Prairie Island Nuclear Generating Plant Units 1 and 2  
Dockets 50-282 and 50-306  
Renewed License Nos. DPR-42 and DPR-60

Supplement to 10 CFR 50.55a Requests (RR) 1-RR-5-2 and 2-RR-5-2 (TACs MF4835 and MF4836) Associated with Prairie Island Nuclear Generating Plant (PINGP) Fifth Ten-Year Interval Inservice Inspection (ISI) Program

### **Supplement to 10 CFR 50.55a Requests (RR) 1-RR-5-2 and 2-RR-5-2 Associated with Prairie Island Nuclear Generating Plant (PINGP) Fifth Ten-Year Interval Inservice Inspection (ISI) Program**

**FLOW DIAGRAM**  
**COOLING WATER-TURBINE BLDG**  
**UNIT 1**

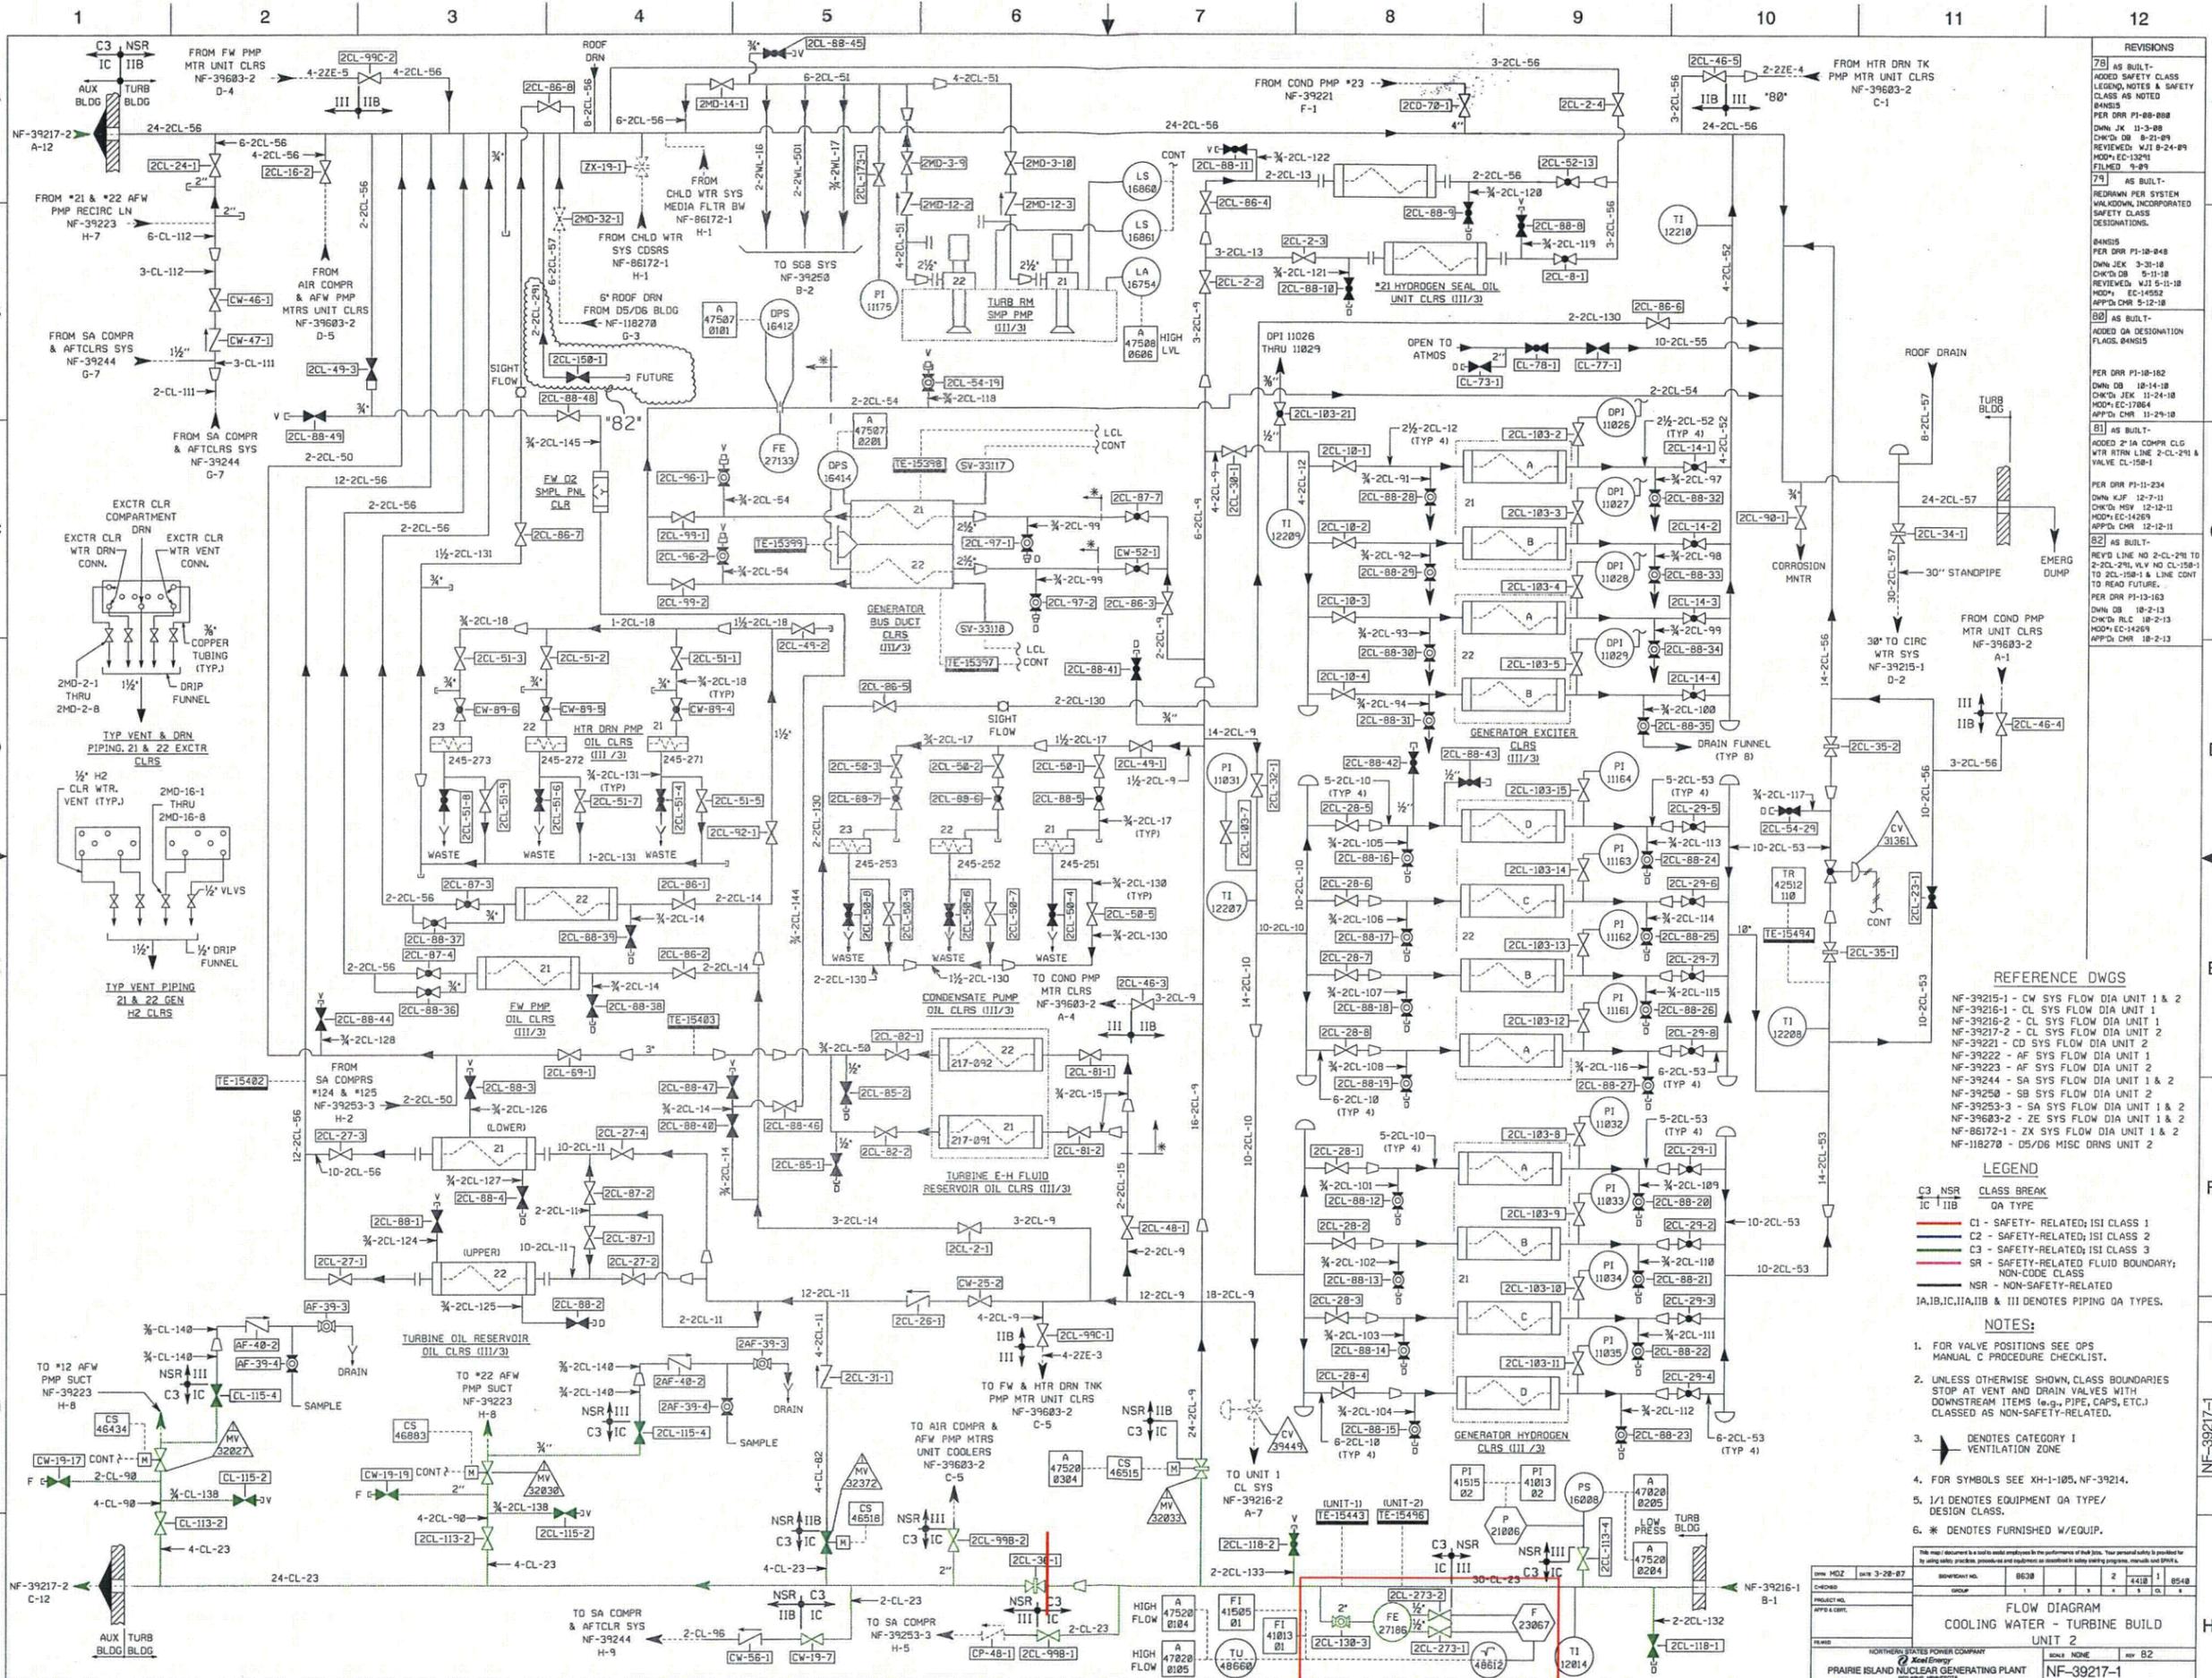
The NRC staff understands that a flow meter is located at the vicinity of the pump discharge nozzle. Discuss whether a flow meter is located at the other end of discharge pipe such that if there is a leak between the pump discharge nozzle and the pipe end, the differences in reading between these two flow meters would indicate the leak rate. Similarly, discuss whether a flow meter is located at the pump suction nozzle and at the suction pipe intake opening.

The boundary of line 30-CL-20 is shown on NF-39216-1 and NF-39316-2 with a red line. The boundary of 30-CL-23 is shown on NF-39216-1 and NF-39217-1 with a red line. The direction of the cooling flow is indicated on the P&ID with arrows. Pressure indication and flow meters are notated on NF-39216-1, NF-39216-2, and NF-39217-1 with red rectangles. The pipe segments that are buried are shown on Figure 1 below.

There is one flow meter for each CL header (FE-27185 and FE-27186 as shown on drawings NF-39216-2 (Attachment 2) and NF-39217-1 (Attachment 3)), located in the Turbine Building downstream of the buried sections of pipe and prior to entering the Auxiliary Building. Due to the location of the Turbine Building flow meters downstream of the buried piping, a decrease in pump head could indicate leakage between the pump discharge and these flow meters.
